Re: ACD FREE Modification Proposal

Summary:

Schematic of the Proposed Circuit Modifications:

Proposed Circuit

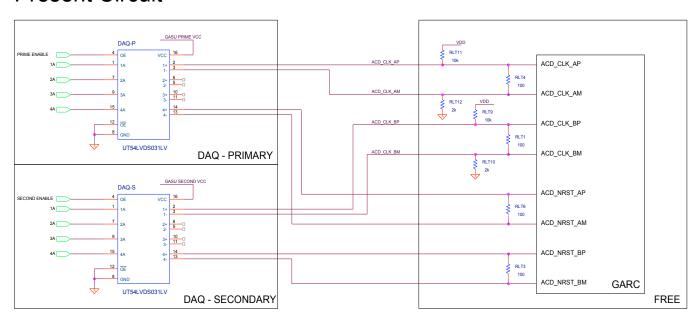
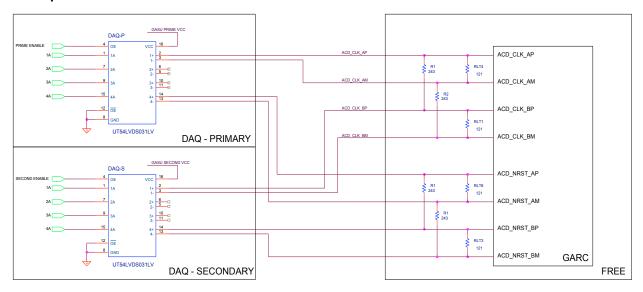
The proposed modification involves cross-strapping the clock and reset inputs to allow a portion of the transmitted signal to be seen by both sets of receivers. The circuit as it presently exists on the FREE card is shown below:

The schematic of the proposed fix to the flight FREE cards is shown below:

Total termination impedance using the 121 Ω resistors at the receiver inputs and the 243 Ω cross-strapping resistors is:

$$Z = \frac{(121)(243 + 121 + 243)}{121 + 243 + 121 + 243} = 100.9\Omega$$

which is close to the desired 100Ω termination.

In this proposal, cabling reflections from the unterminated, unpowered driver side are quite significant with flight length cables. At the nominal 20 MHz clock rate, this fix does not function reliably. SLAC has agreed to configure the GASU to drop the clock rate to approximately 1 MHz for 1 second at FREE board turn on to mitigate this problem. At the 1 MHz rate, the reflections do not hinder operation and the FREE card redundant (unpowered) receiver will receive clocks reliably (which is the goal of this modification). After 1 second, SLAC will command the GASU to return the FREE card clock to the nominal 20 MHz rate for operations.

The proposed change is to be made on both the clock and the reset signal paths. If both the primary and redundant clock receivers can be active, it is necessary to ensure the reset level is held inactive.

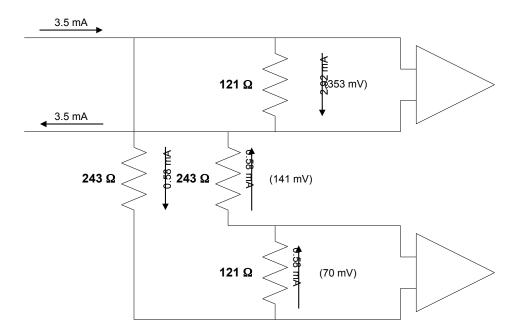
The calculated signal amplitudes based on nominal LVDS currents are shown below:

The primary (powered) receiver maintains the ~ 350 mV signal across the 121Ω resistor with 2.92 mA of (nominal) current. $580 \,\mu\text{A}$ current is shunted through the 243 ohm resistors and the redundant (unpowered) receiver. This provides ~ 70 mV of difference across the unpowered receiver, which is enough to toggle the GARC receiver in the absence of cabling reflections.
